Addendum # 1

Bid Opportunity: 25-7632-RFT - Crestview Public School Main Office Renovation and Ventilation Upgrade

ADDENDUM NO. 1

ADDENDUM 01

A-BLOCK C LIGHTING RENOVATION PLAN

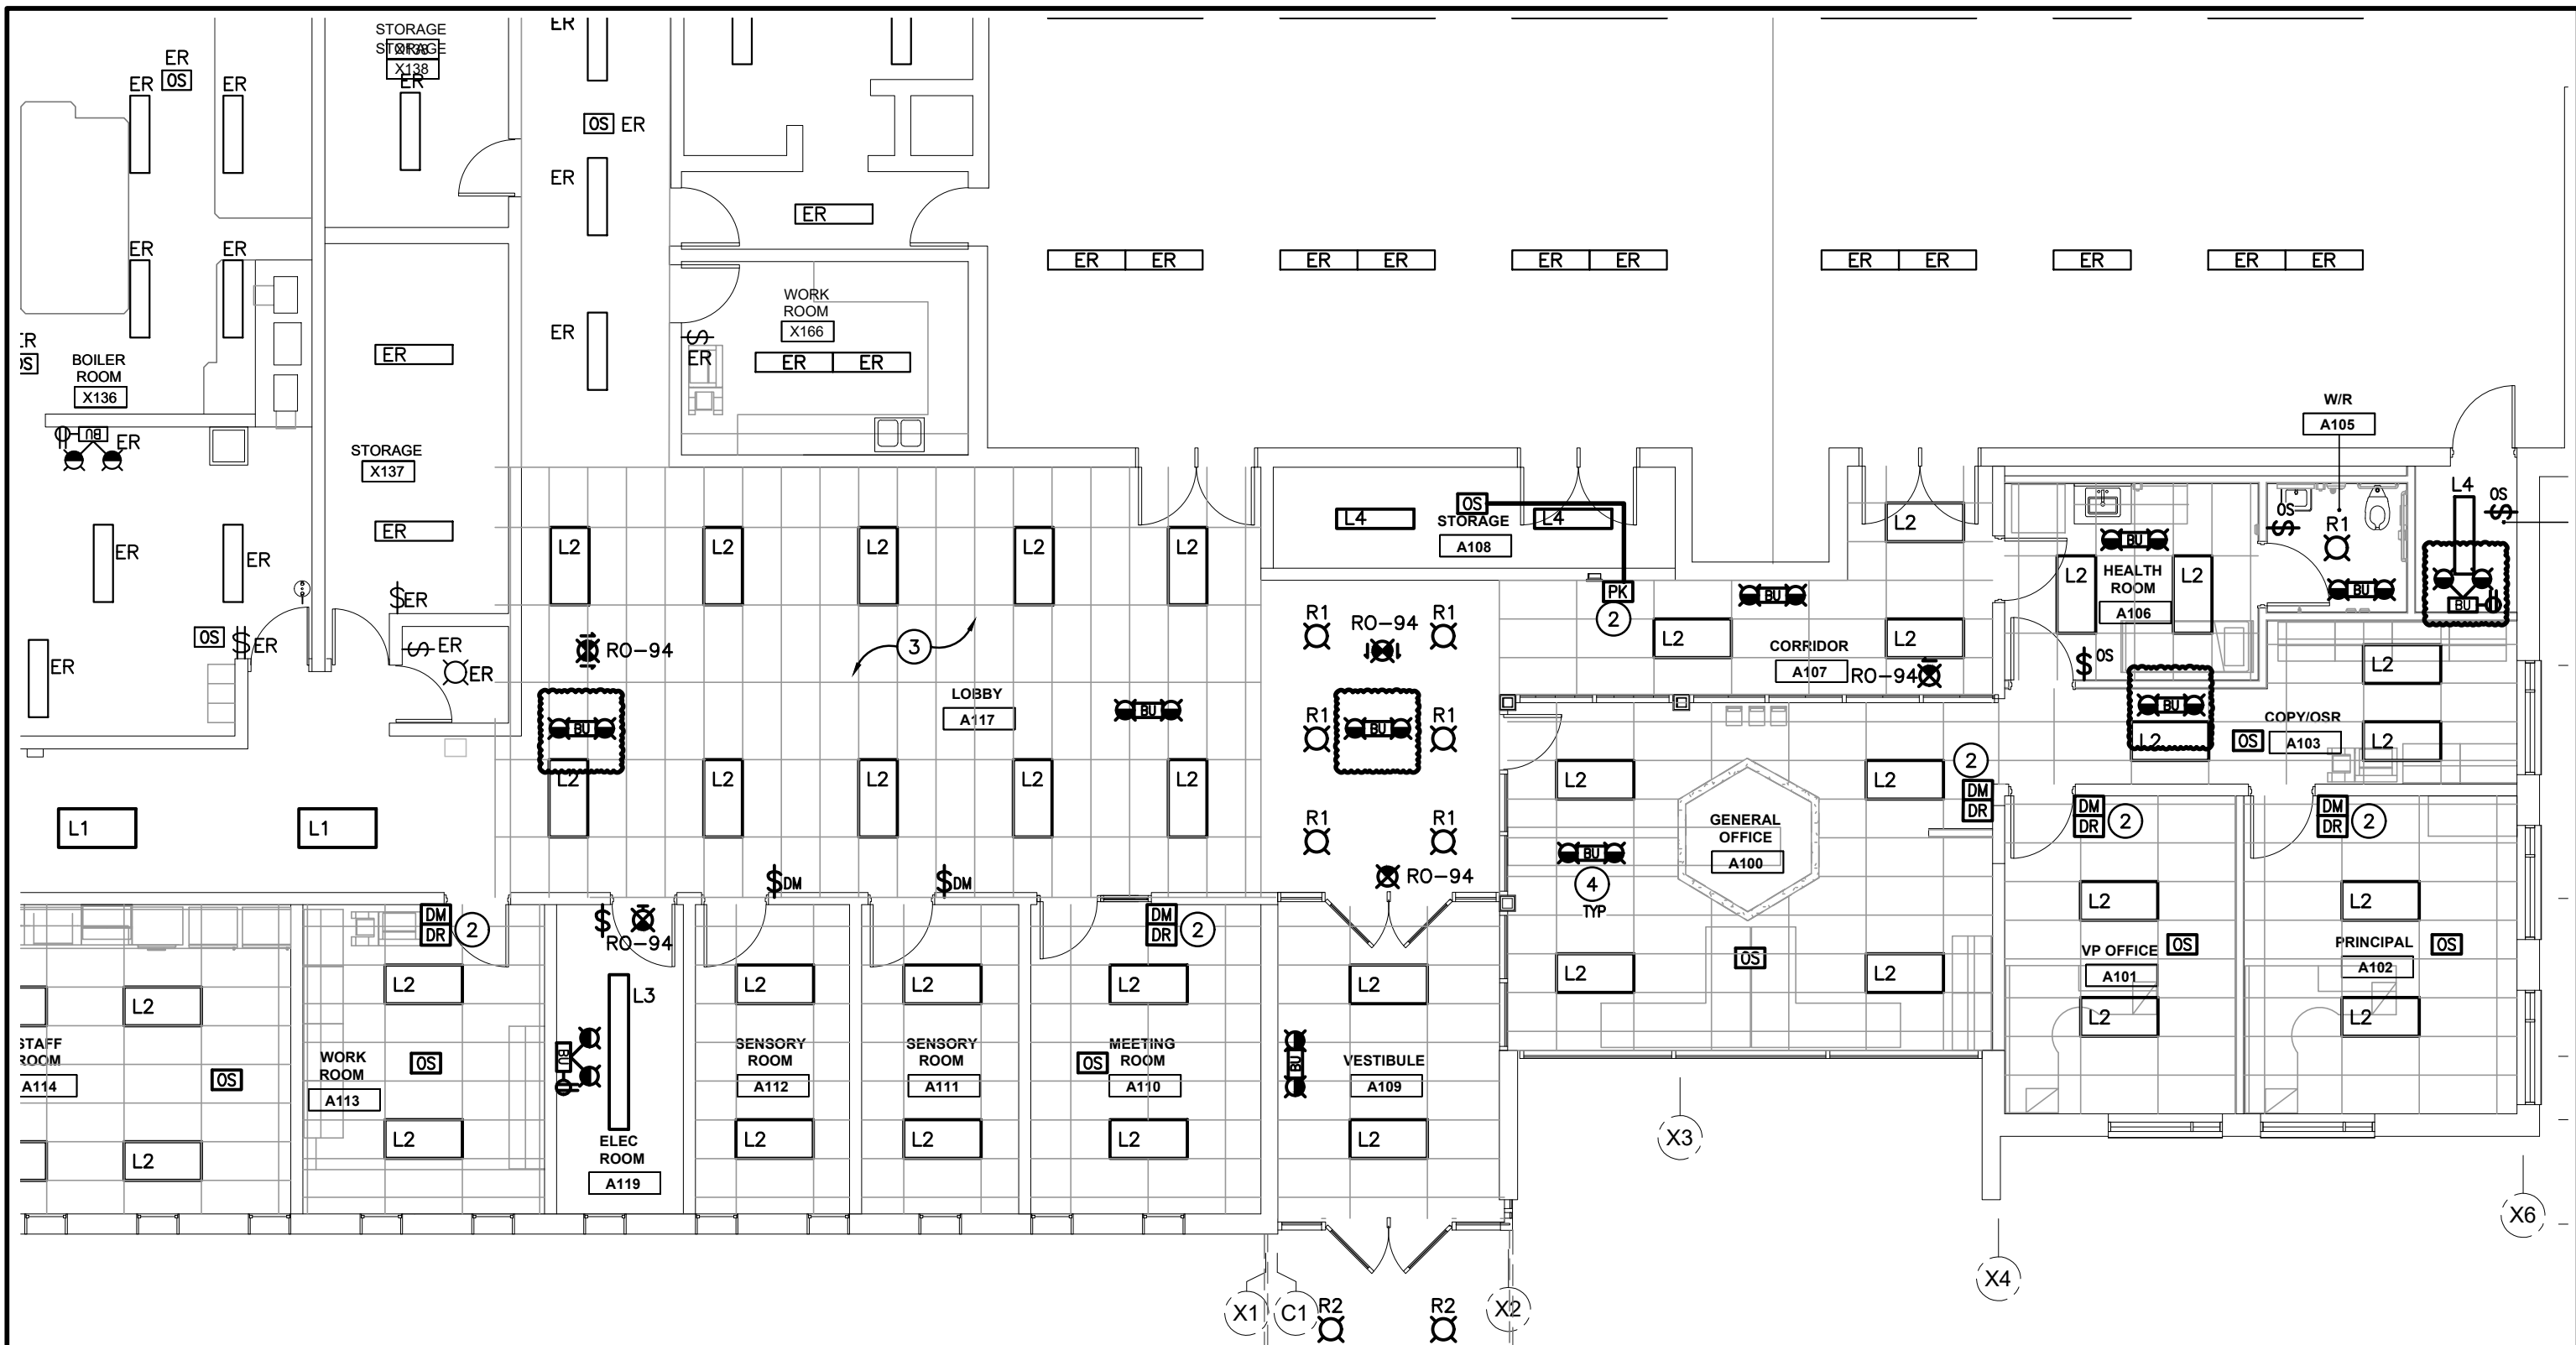
- .1 Electrical contractor to provide additional battery units with emergency heads added to lobby and copy/OSR room. Refer to attached sketch ADD1-E02.
- .2 Revised water meter room battery unit to be wall mounted. Remove the exit sign within the water meter room. Refer to attached sketch ADD1-E02.

- .3 All new exit signs to have dedicated circuit. Refer to attached sketch ADD1-E02.

A-BLOCK C POWER & SYSTEMS RENOVATION PLAN

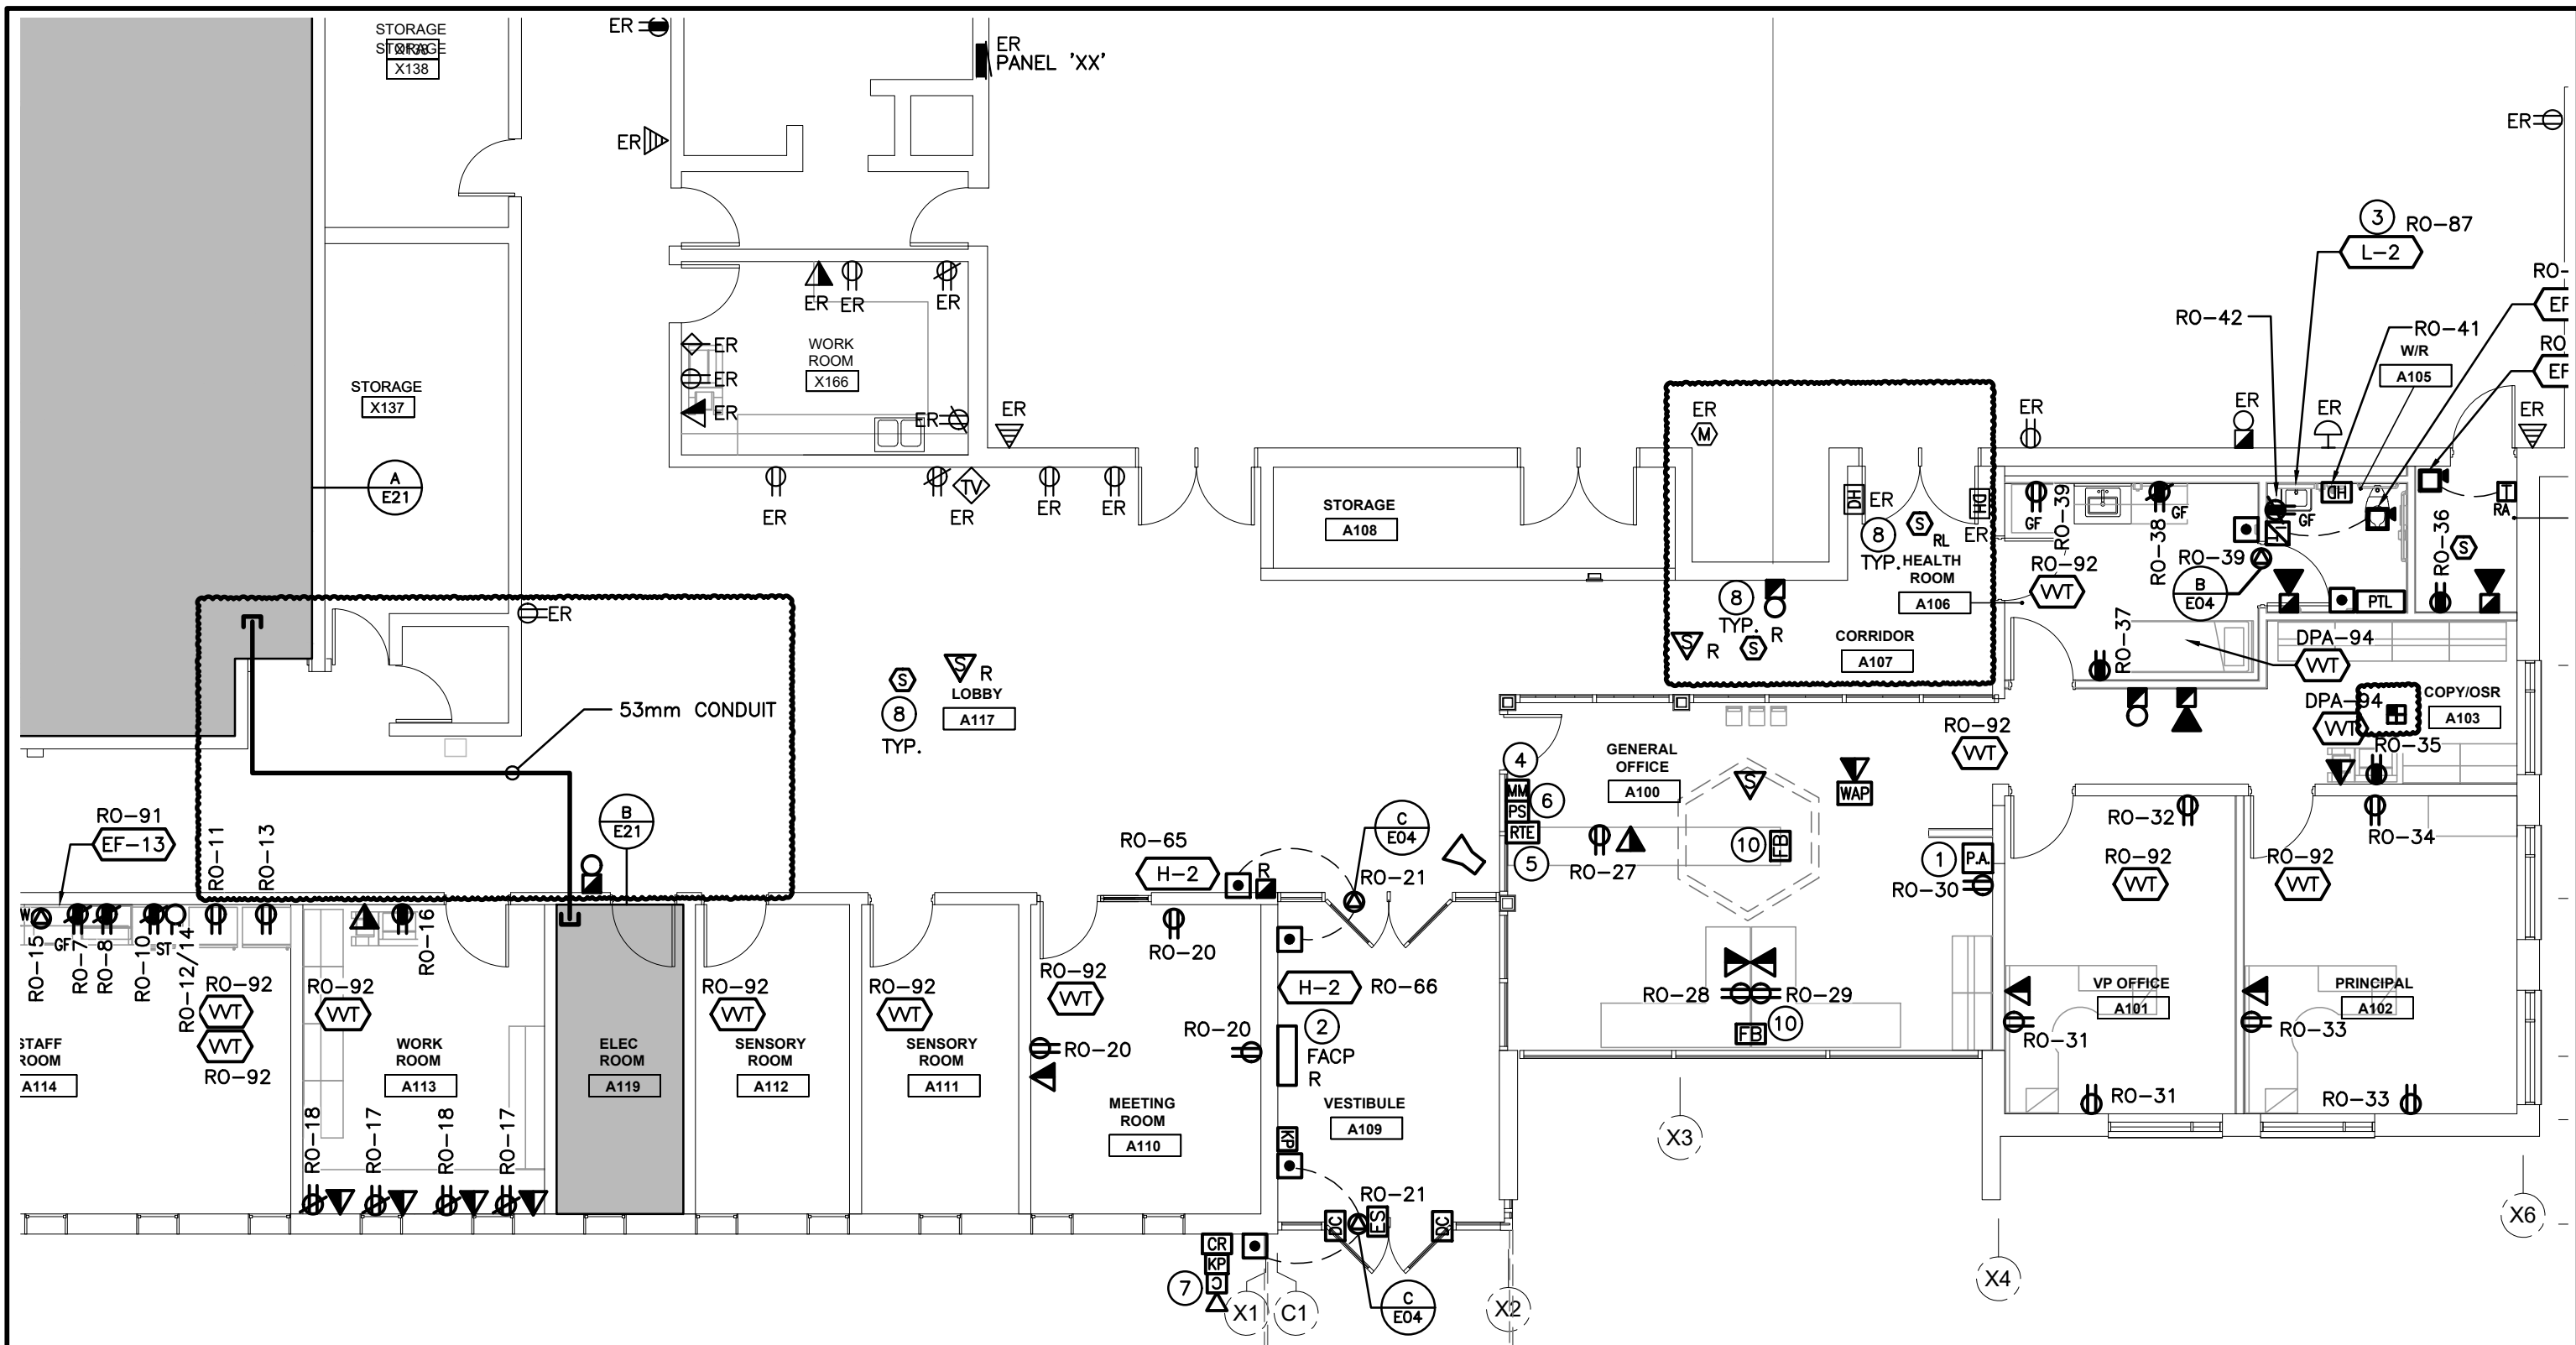
- .1 Electrical contractor to provide 30A L5-30R receptacle on backboard for UPS at IT rack location. Provide new 30A-1P breaker in Panel RO. Refer to attached sketch ADD1-E04.
- .2 WRDSB phase loss relay detail added to drawings for reference regarding phase loss relay scope for new switch board. Refer to attached sketch ADD1-E05.
- .3 Electrical contractor to provide a junction box and dedicated weatherproof receptacle for remote meter antenna. Additional clarifying notes added to drawing regarding this scope. Refer to attached sketch ADD1-E04.
- .4 Removed alarm bell in the electrical room from scope. Refer to attached sketch ADD1-E04.
- .5 Electrical contractor to provide 30A-3P breaker within Panel RO for surge protection device. Refer to attached sketch ADD1-E04.
